Proposed Code Modifications

**This document created by the Florida Department of Business and Professional Regulation -
850-487-1824**

TAC: Fire

Sub Code: Building

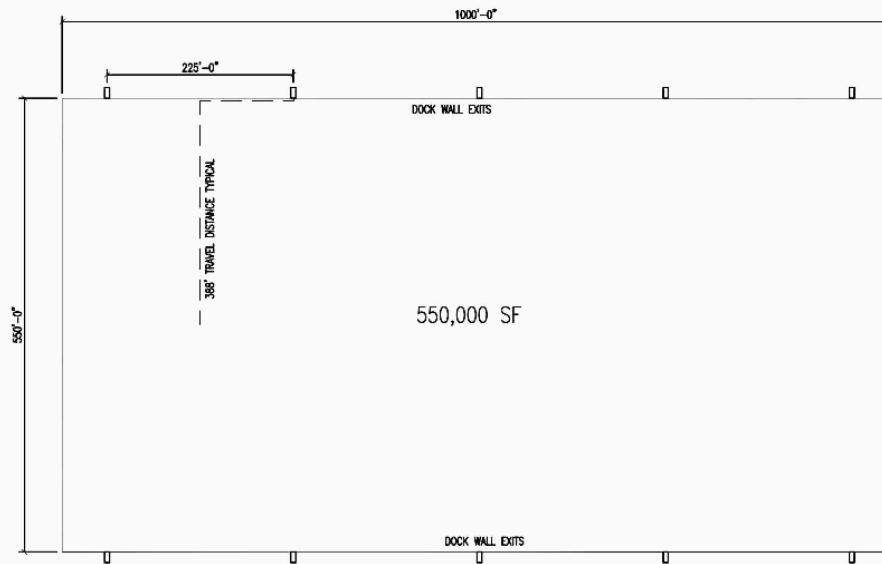
Land owners that have planned for large distribution centers are finding that businesses can no longer build the size and depth of buildings for S-1 Storage that have been allowed before the 2014 code change. Many of such parcels are not easily converted to other uses as the large DC sites do not generally share property lines with smaller depth sites for non-related uses.

Going back to 400' allowed travel distance for S-1 in sprinkled buildings will allow for a relative reduction in construction costs due to greater building efficiency.

EXAMPLE A
FBC 2010 (PROPOSED FOR 2017) - 400' TRAVEL DISTANCE FOR S-1 SPRINKLERED

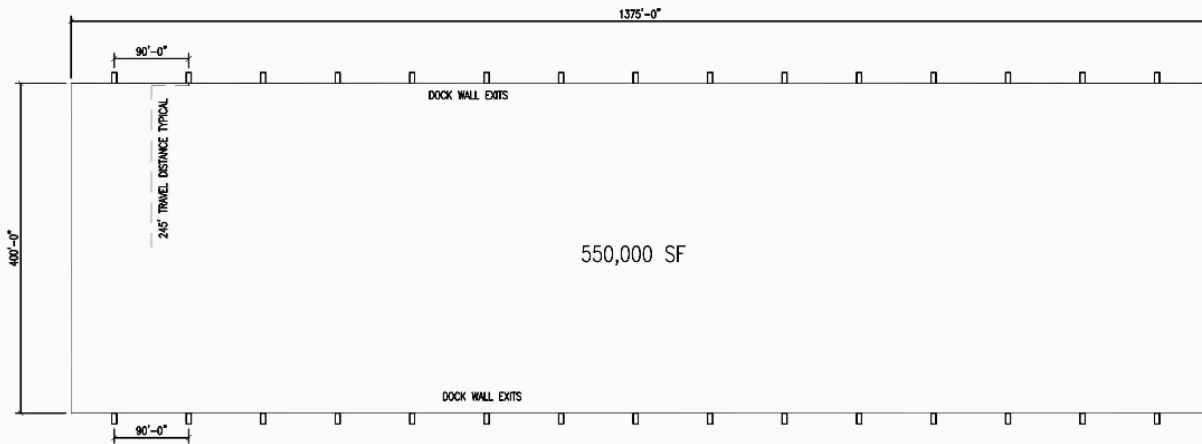
Providing a quantitative estimate for additional cost is difficult, since it would vary with each building configuration; however I am attaching a general example for your reference and offer more information below.

Allowing 400' allowed travel distance for S-1 in sprinkled buildings will allow companies with large Distribution Center, needs to operate more efficiently.
